Interactive comment on “An efficient semi-distributed hillslope sediment model: the Anjeni in the sub humid Ethiopian Highlands” by S. A. Tilahun et al.

S. A. Tilahun et al.

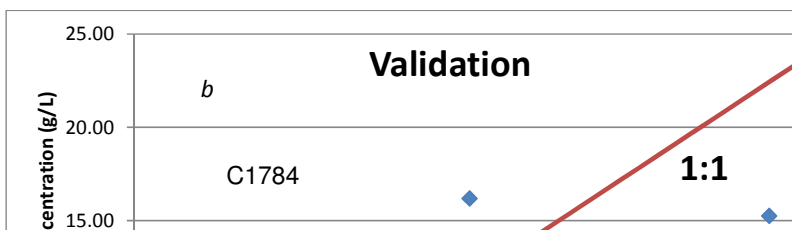
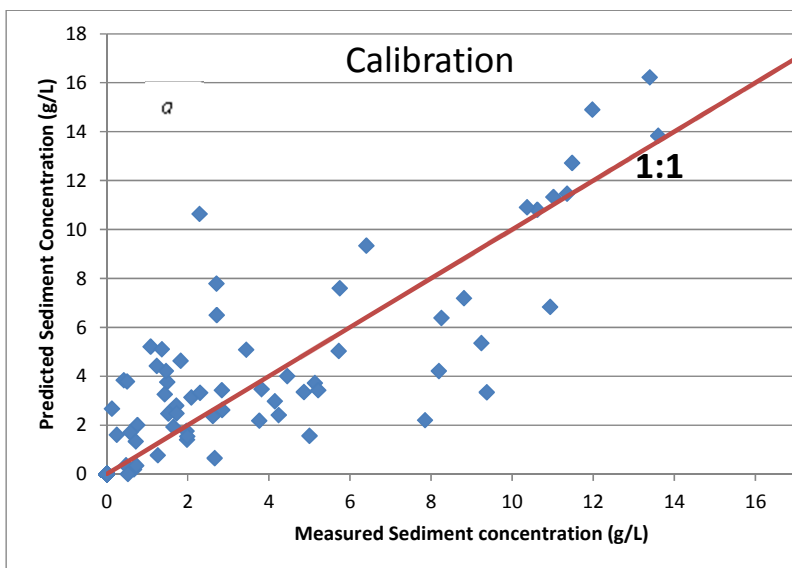
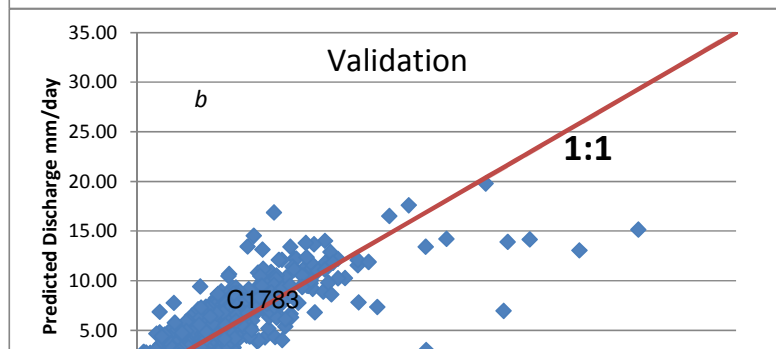
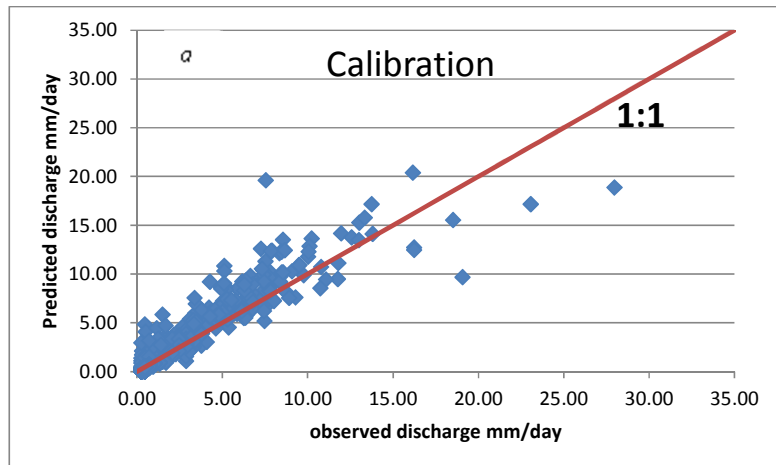
Plots like figure 4 and 5 always give a false impression of the goodness of the model predictions. Off course, the predicted runoff will increase when the observed runoff increases: this is quite logic as there will only be runoff after rainfall. Likewise, if there is no runoff, there will be no sediment transport/concentration. It would therefore be better to plot the observed versus the predicted values of daily Q and C in one graph to see how far the predictions plot from the 1:1 line.

As per suggestion, plots of observed versus predicted values of daily Q and C are included in the document. This is done for both calibration and validation steps (Figures 4 and 6). The figures are attached as figure 1 and 2.

Figure 1: Location, watershed boundary and drainage map of Anjeni Watershed

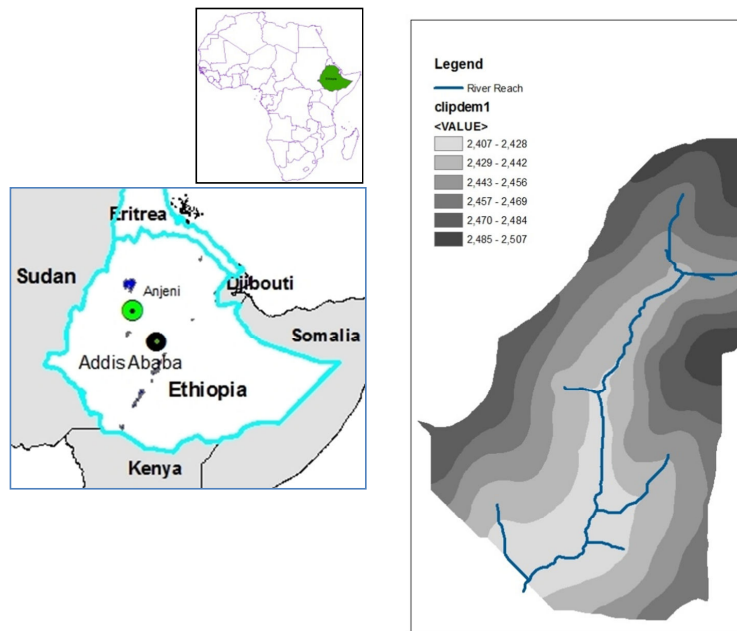
The quality of Figure 1 is insufficient, especially the DEM (only three odd-chosen colors).

Figure 1 is improved and can be referred and is replicated as Figure 3
